Response to Supplemental RAIs for NEI 06-14A, Revision 6

Response to Supplemental RAIs for NEI 06-14A, Revision 6

Figure II.1-1

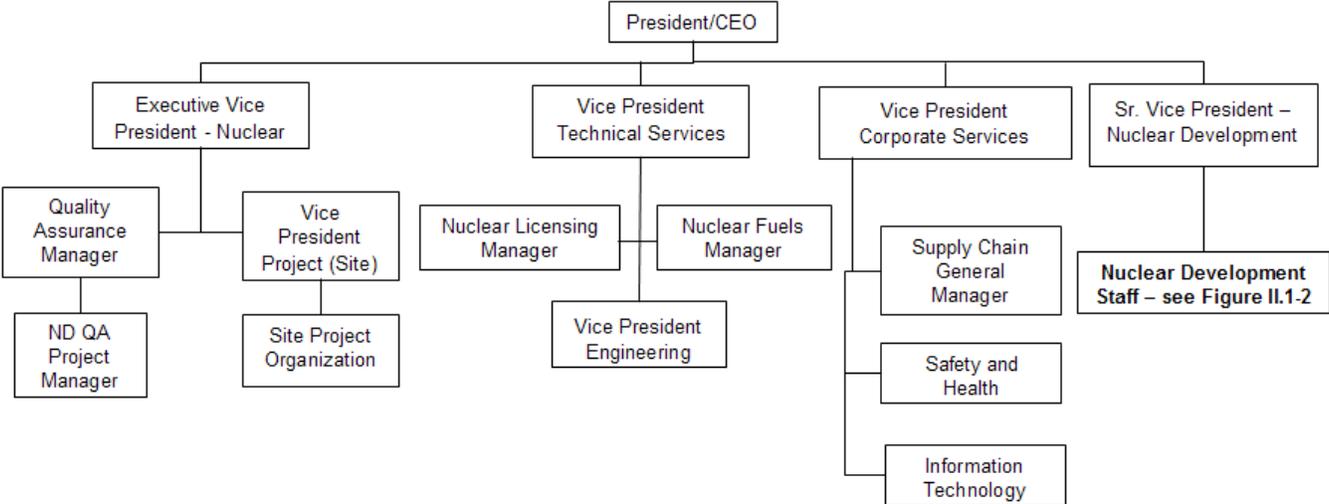
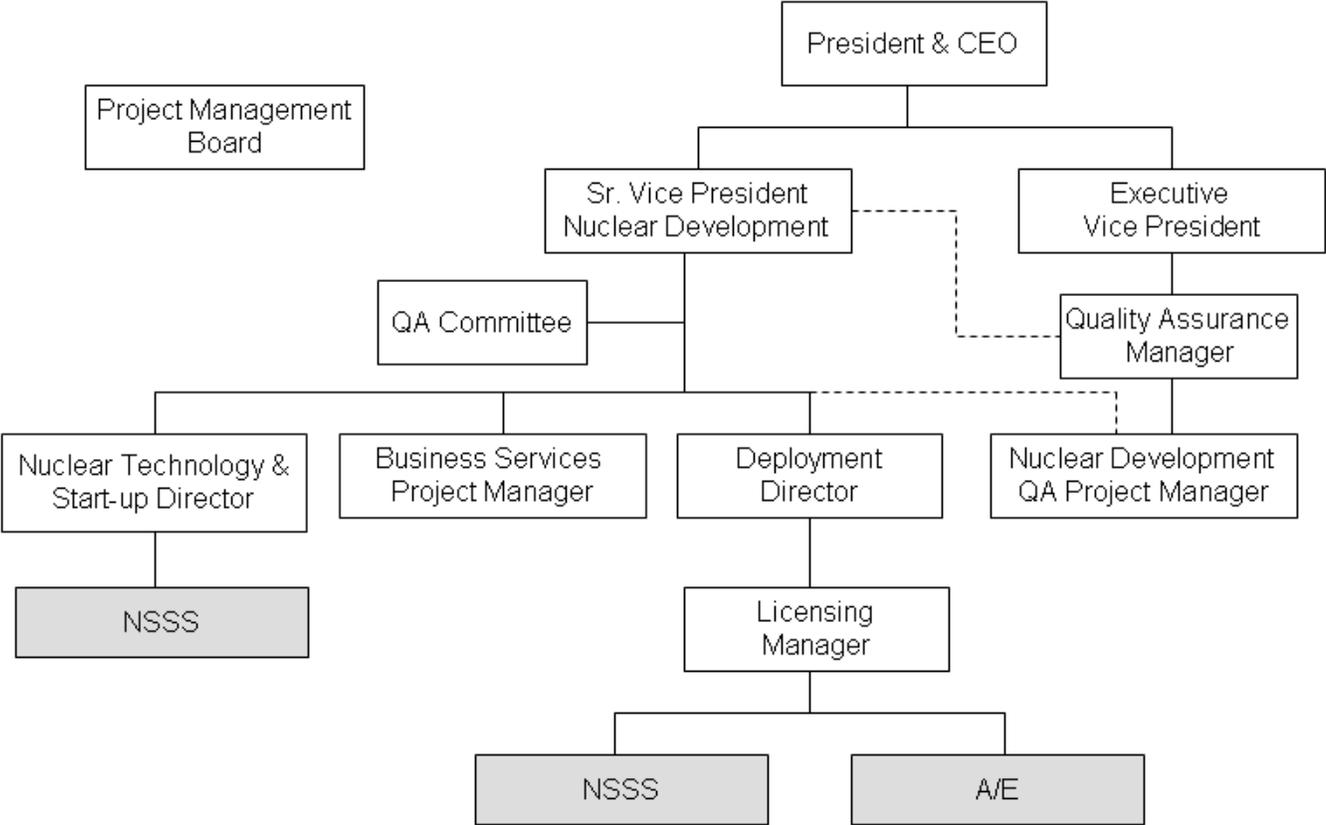
1. With respect to RAI #1, which requested additional guidance on organizational structure, the NRC staff acknowledged the additional guidance provided. However, the organizational description and charts provided in Section 1 of NEI 06-14A still needs to include:

- b. An organizational description that includes management levels that implement quality activities.
 - c. The organizational descriptions and charts for the operations phase, including both onsite and offsite management and the independent review function.

Response: NEI has added notes to provide additional guidance for the content of the organizational description. The NOTE at the beginning of the Organization was enhanced to emphasize the need for the organization description of the responsibilities and relationships during all phases of applicability for the QAPD, including those management positions responsible for implementing portions of the QA Program. A NOTE was added to the sample organization charts emphasizing that organization charts need to be included for all phases of applicability of the QAPD as well as for all on-site and off-site organizations implementing the QA Program. Emphasis was added to stress the importance for the description to address the transition of responsibilities between organizations when multiple phases are addressed for the QAPD applicability. A NOTE was added acknowledging that an applicant/licensee may provide the required organization description by incorporating by reference information from another section of the FSAR but by so doing, the regulatory change process established 10 CFR 50.54(a) would be applicable to that incorporated section.

Because the NEI template may be used by an applicant/licensee to address the QA Program for any or all of a variety of applications (e.g. Design Certification, Early Site Permit, Construction, Operations), we feel that adding additional detail to the example Organization section would only serve to confuse future users of the template. NEI added a NOTE emphasizing that the sample Organization description and Organization Charts provide a simple organization for illustration of potential applicability.
